**STAFF REPORT: 6/14/2023 MEETING**

**ADDRESS: 1 PARK AVENUE**

**APPLICATION NO: #23-8390**

**INSTALL AWNINGS, CANOPIES, AND PERGOLAS; ESTABLISH OUTDOOR PATIOS;  
REPLACE STOREFRONTS (INCLUDING AT DESIGNATED INTERIOR)**

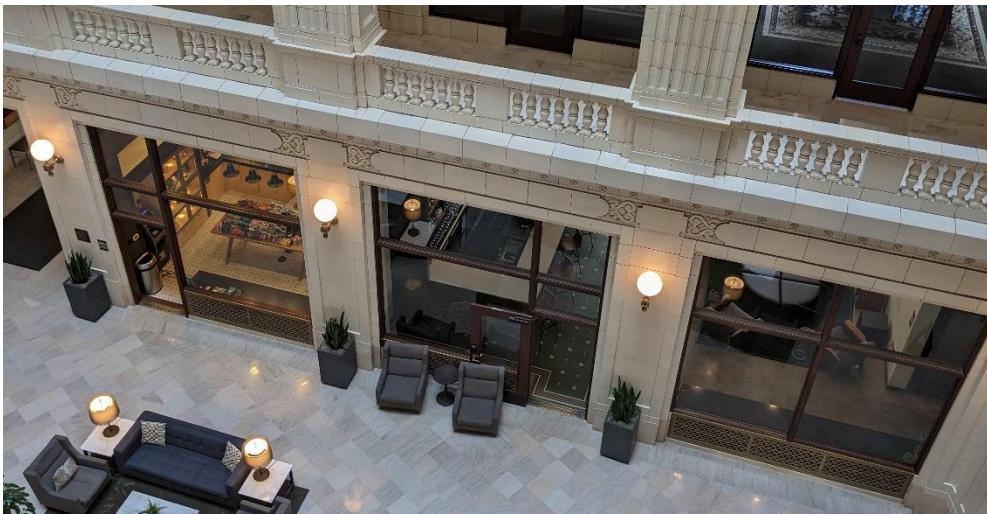
The building's first story exterior includes non-historic aluminum storefronts. The first story entrance at the building's north elevation is sheltered by a recently installed, internally lit-brightly colored canopy which has been affixed to the people mover platform that is directly to the north of the building. Finally, note that the interior atrium lobby includes four mahogany storefronts that are included in this applicaiton, each of which displays a brass grille base. Per project construction drawings, these storefronts were refurbished using in kind materials during the building's recent rehabilitation.
